**Pre-Bid Meeting Minutes
UNC Charlotte Union Parking Deck Expansion
SKA Project No. 160367.0
SCO ID No. 16-15657-02A
March 9, 2017
(Issued March 14, 2017)**

NOTICE TO BIDDERS

EXPLANATION OF BASE BID AND UNIT PRICES FOR DRILLED PIERS

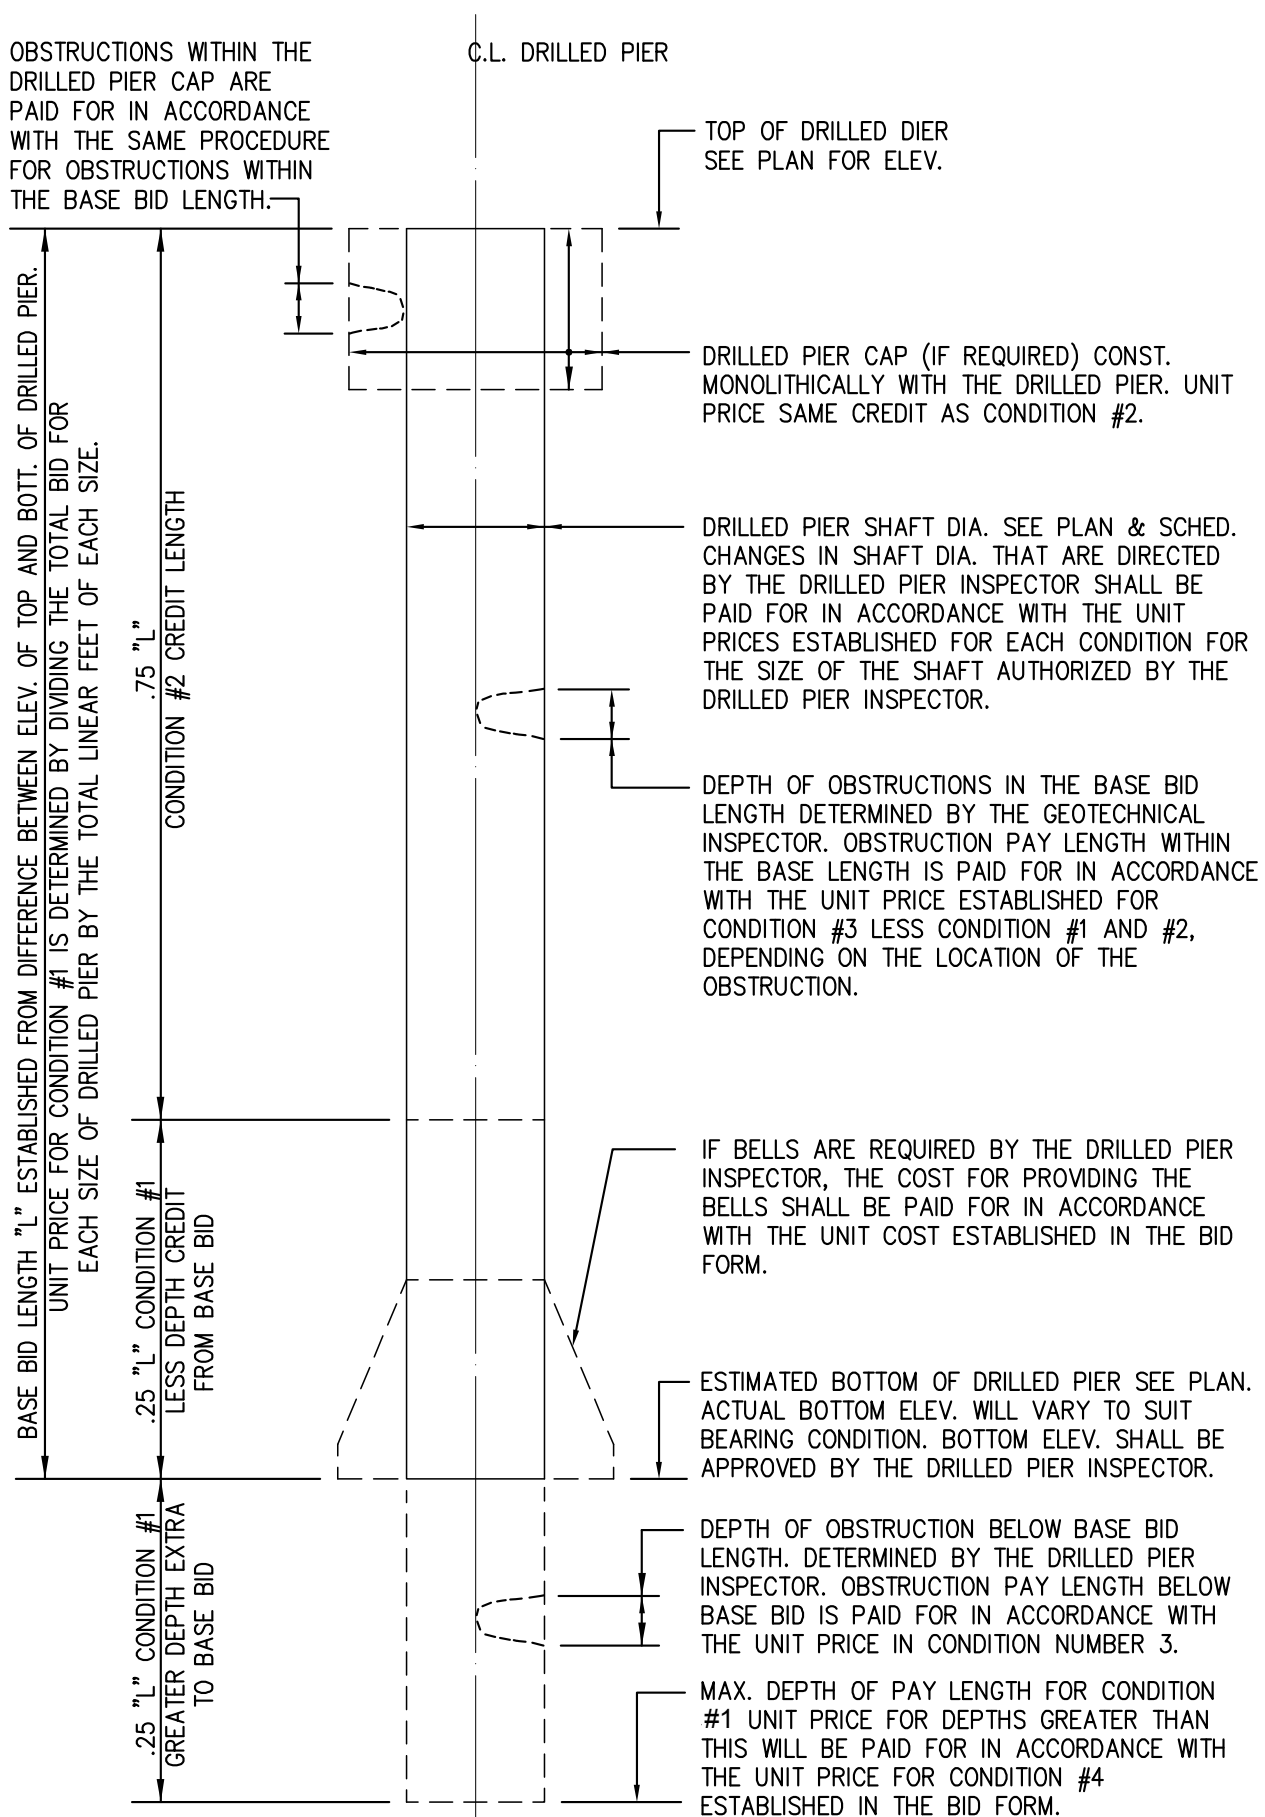
1. Condition #1 applies as a unit-price credit or extra for variation in the installed length of each individual drilled pier that does not vary by more than 25% of the Base Bid Length of each drilled pier as shown on the Drawings.

2. Condition #2 applies as a unit-price credit for that length of an individual drilled pier that is not installed above the elevation of the bottom of the drilled pier shown on the plans less 25% of the Base Bid Length of the drilled pier shown on the plans.

3. Condition #3 applies as a unit price for obstructions. Obstructions within the Base Bid Length will be paid for in accordance with the unit price established for Condition #3 less the unit price for earth in either Condition #1, or #2, depending on where the obstructions are found. Obstructions found below the Base Bid Length will be paid for in accordance with the unit price established for Condition

4. Condition #4 applies as a unit-price extra for any length of drilled pier installed at a depth below the bottom elevation of the drilled pier shown on the plans plus 25% of the Base Bid Length of the individual drilled pier as shown on the Drawings.
